AMENDMENTS TO THE DRAWINGS

REMARKS

Objection to the Drawings

FIG 3

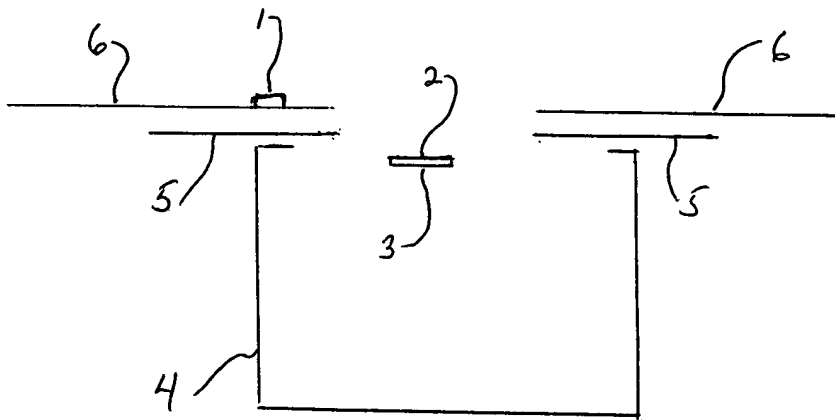
The Examiner objected to the drawings as not showing every feature of the claimed invention. The Examiner states that the two-sided display, same information displayed must be shown. Applicants submit that the Examiner's statement is incorrect in that the two-sided display has different information displayed on opposite sides. However, Applicants are submitting new

Submitted herewith is an annotated sheet showing new Figure 3. New Figure 3 more clearly shows the two-sided display having different information displayed on opposite sides.

Fig. 3 which shows this arrangement more clearly. This figure shows the elevator car 4 when viewed from the top with the two-sided display mounted in front of the elevator door so that display 2 can be observed from the lobby while display 3 can be observed from inside the elevator. Also, display 1 is shown as being mounted on the lobby wall. This arrangement is also shown in Fig. 2. However, Fig. 3 has been submitted to show this more clearly from a different angle. Accordingly, this drawing objection is believed to be overcome.
